MFN 06-268

**Subject: Response to Portion of NRC Request for Additional Information
Letter No. 43 Related to ESBWR Design Certification Application –
ESBWR Containment Design and Probabilistic Risk Assessment Re:
Containment Fragility Analysis – (Release A) RAI Numbers 6.2-95,
6.2-97, 19.2-41, 19.2-44 to 19.2-46, 19.2-49, 19.2-50 and 19.2-57**

**Partial Response to NRC RAIs 6.2 and 19.2 Release A
RAI 6.2-95, -97. 19.2-41, -44,-45, -46, -49, -50 and -57**

Figure 19.2-45(1) Locations of the data in PRA Table B.8-1 as indicated in Table 19.2-45(3). Upper Drywell and Wetwell.

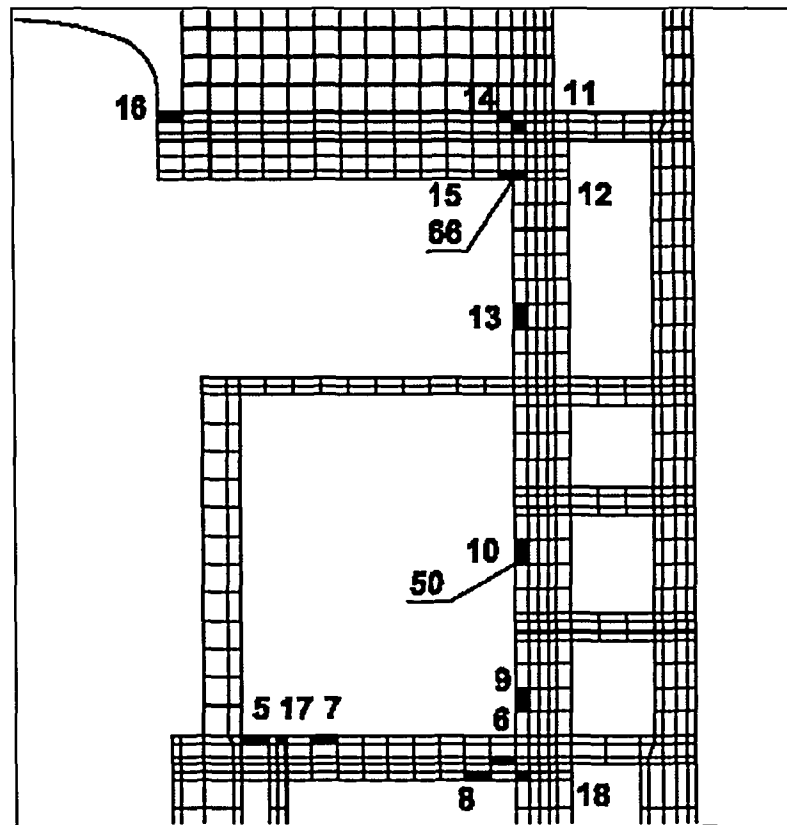
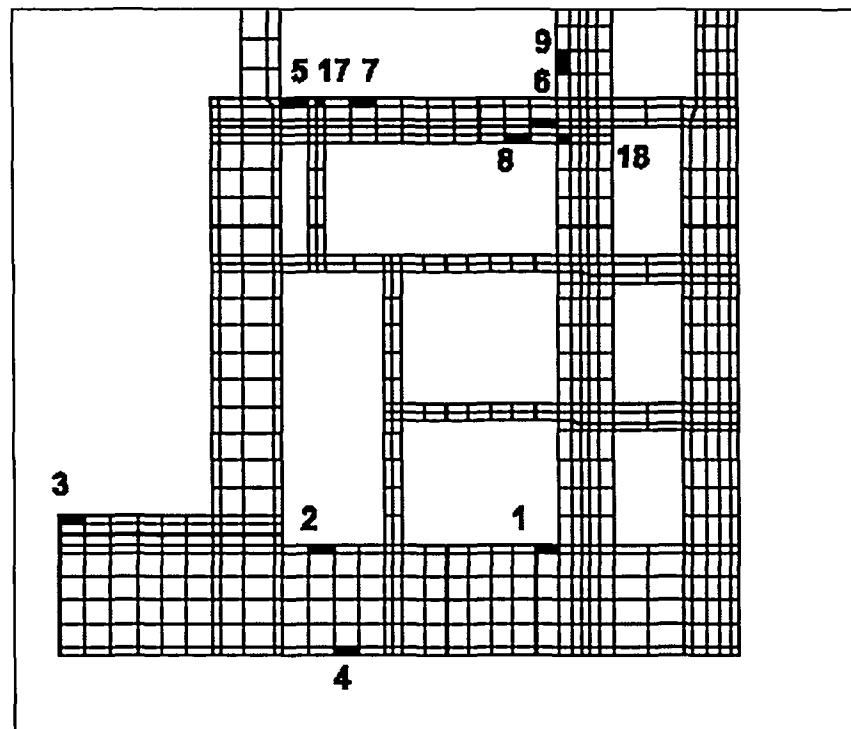
- d) Provide the max. rebar strains (including locations) at each pressure level for all components in Table B.8-1, and provide a discussion of comparisons of max. rebar strains with the max. liner strains listed in Table 8.1-1.*

- f) What is the radius at the location of the reported "Max. Radial Defl. Wetwell", and what are the calculated strains at this location (i.e., radial deflection divided by radius)? Compare to the rebar strains.*

- d) Table 19.2-45(2) and 19.2-45(3) show the maximum rebar strain at each pressure level for all components in Table B.8-1, as well as their locations. See response to RAI 6.2-95 for a detailed comparison of rebar strains and liner strains at 1.468 MPa.

- f) The reported Max. Radial Deflection, is the maximum radial displacement in any point of the containment. In this case it is measured in the middle of the wetwell and is 13.02 mm. For a 18,000 mm inside radius of the containment, radial strain is 0.072%. Radial strain for the rebars in the same location is 0.017% (point 50 in Figure 19.2-45(1)) which is the same order.

Figure 19.2-57(1). Drywell Temperature History for 80 cm Diameter Breach of RPV

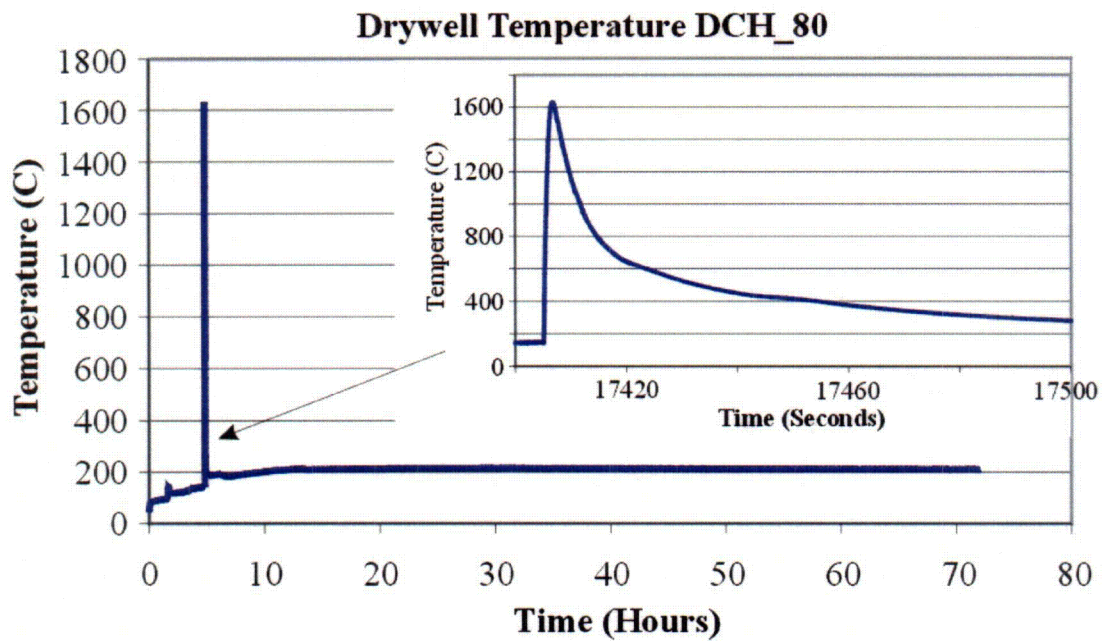
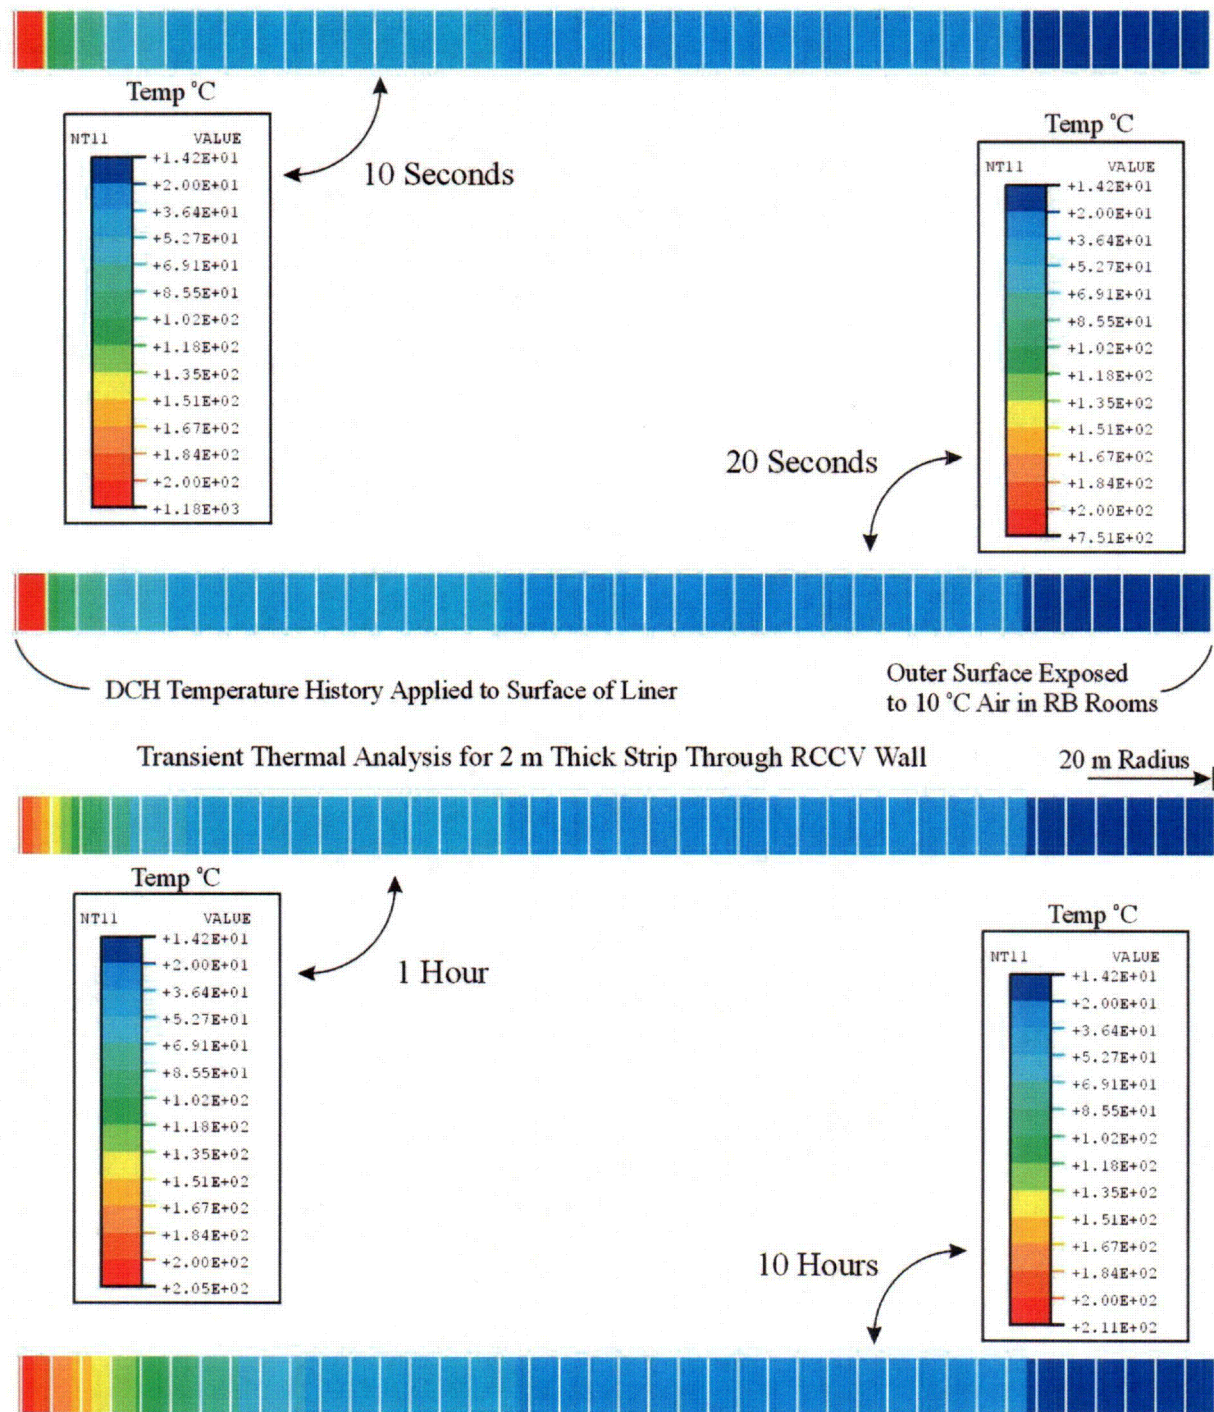
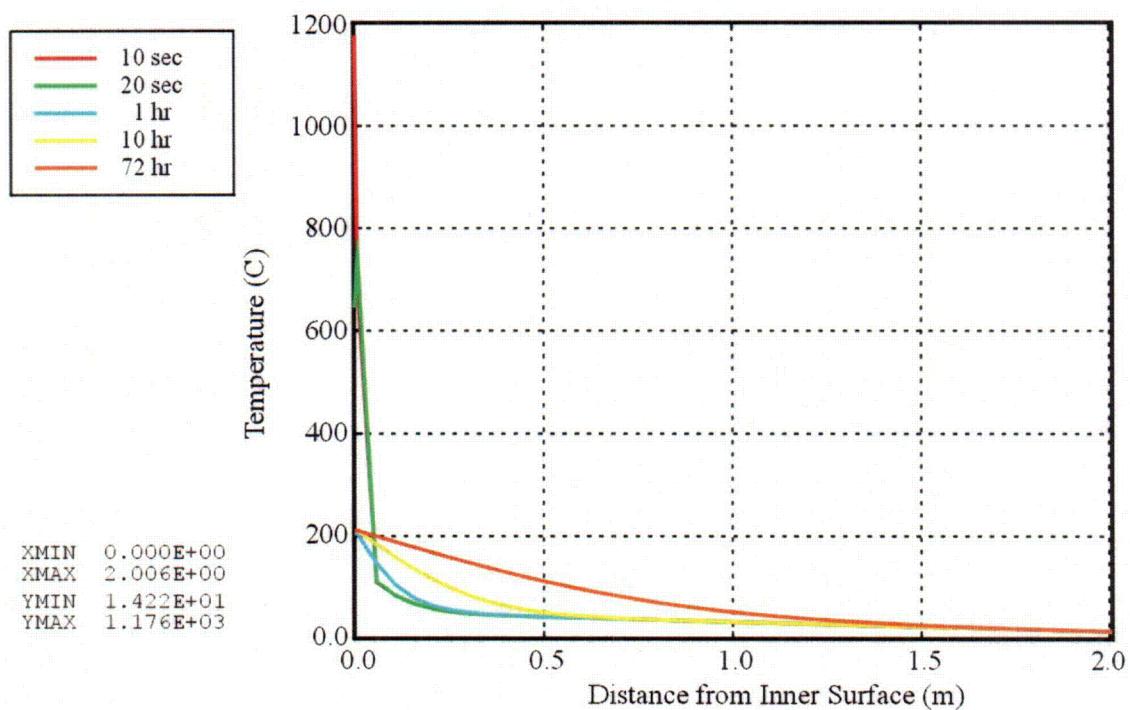
In PRA, Section 21.3, GE described that the DCH generated superheated gas could induce temperatures in excess of 1000°K in the upper drywell space. It is not clear how the concrete performs under such high temperatures. Provide:

- a) Calculations were carried out with the MAAP code to determine the long-term temperature history of the upper drywell atmosphere under the assumption that the PCCS and BiMAC systems were functional. We considered a bounding case as found in Section 21 of NEDO-33201 Rev 1 analysis of the DCH event, and we made sure that the starting point of this long-term, systems analysis matched the post-DCH temperature levels found in the DCH event assessment of Section 21 of NEDO-33201 Rev 1. The result is shown in Figure 19.2-57(1). Note as a result of the cooling systems the DCH-induced high temperature spike is just that; in other words it is seen to dissipate in a matter of a few seconds, reaching down to less than 3000 C in ~1 minute. From then on the temperatures decay slowly down to 2000 C in less than 1 hour where it seems to stabilize for the long term (72 hours and beyond).

We then proceeded to find an upper bound heat up of the concrete by imposing this temperature history on the inner surface of the liner (that is assuming an infinite heat transfer coefficient) along with a gap conductance that was kept conservatively low for the duration of the transient. The results are summarized in Figure 19.2-57(2) and Figure 19.2-57(3). First it is interesting to note that the atmospheric spike attenuates already by the liner, with a peak of only 8000 C. Then we note that the combined effect of slow conduction into the concrete along with the rapid cooling of the atmosphere yields a very slow penetration of a thermal wave whose peak value on the surface is just under 2000 C.
